# Technical Service Bulletin

<b>Subject:</b> <b>REAR A/C VENT COVER LOOSE / DETACHED FROM CARPET</b>	<b>Bulletin No.:</b> 09-016/19
	<b>Last Issued:</b> 03/28/2019

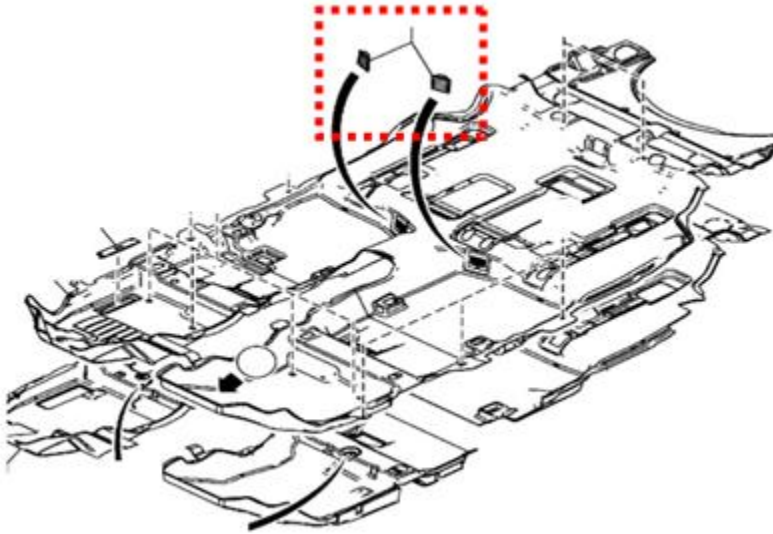
Some customers may notice the rear A/C vent cover is loose / detached from the carpet, which may also be torn or damaged. This concern may be caused when excessive force is applied to the A/C vent cover clip, resulting in a loose or dislodged vent cover. To eliminate this concern, the clip position and configuration of the rear A/C vent cover have been changed to improve its durability.

1. Verify the customer concern.
2. Replace the carpet with a modified one according to the instructions on MGSS online (FLOOR COVERING REMOVAL/INSTALLATION).

- New modified carpet includes new modified A/C vent covers (K131-68-6D1 02).
- If vent covers become loose or detached in the future, replace the vent covers separately.
- New modified vent covers are not compatible with old carpet. New modified vent covers are only compatible with new modified carpet.
- The selector lever component and bracket do not need to be removed.
